Subject: A/YL-PH/1091

回應部門提問

A/YL-PH/1091
交通流量評估

雨水排放建議圖

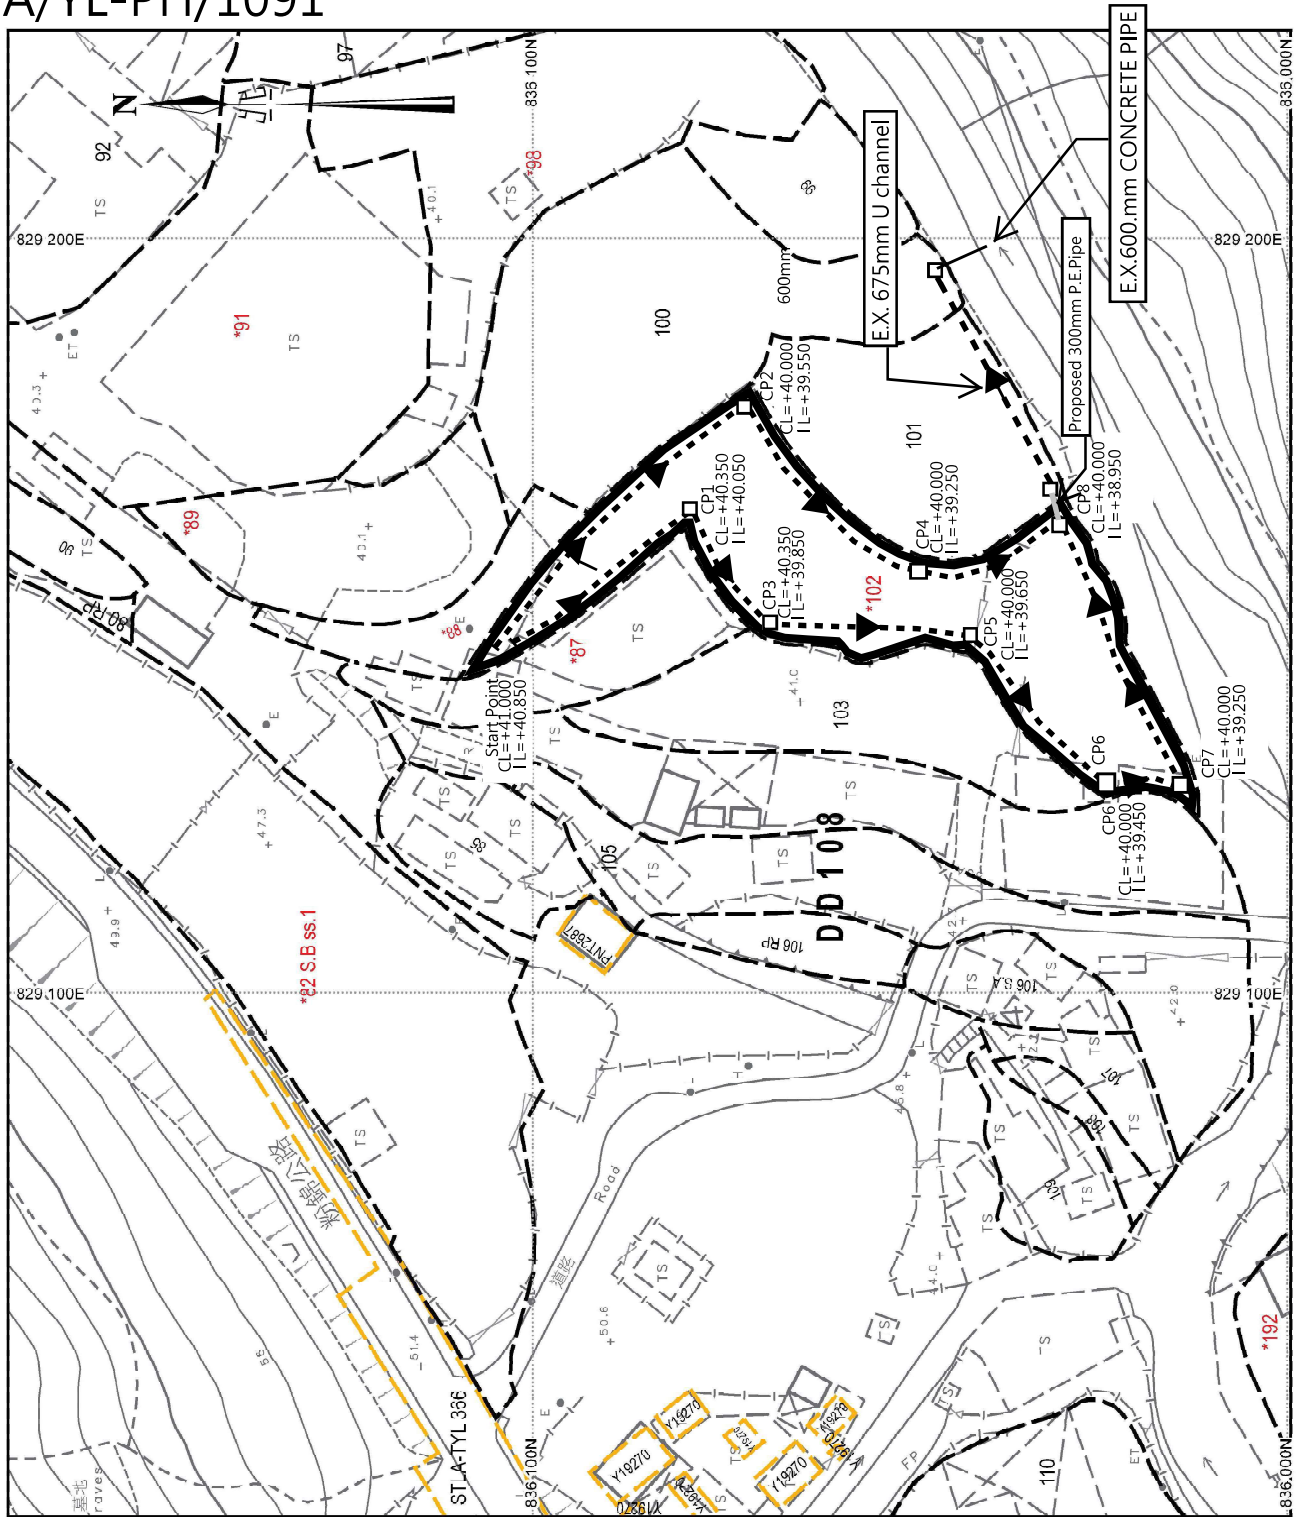
(g) Please show the connection details at discharge point and indicate all C.L., I.L and catchpit/watercourse B.L. in the drawing.

(i) Please provide channel to the entrance to accrue runoff from the application site and to intercept the overland flow from the adjacent lands.

- (l) Cross sections showing the existing and proposed ground levels of the captioned site with respect to the adjacent areas should be given.

已上新設計圖內列明。

已在新設計圖內列明。

已在新設計圖內列明
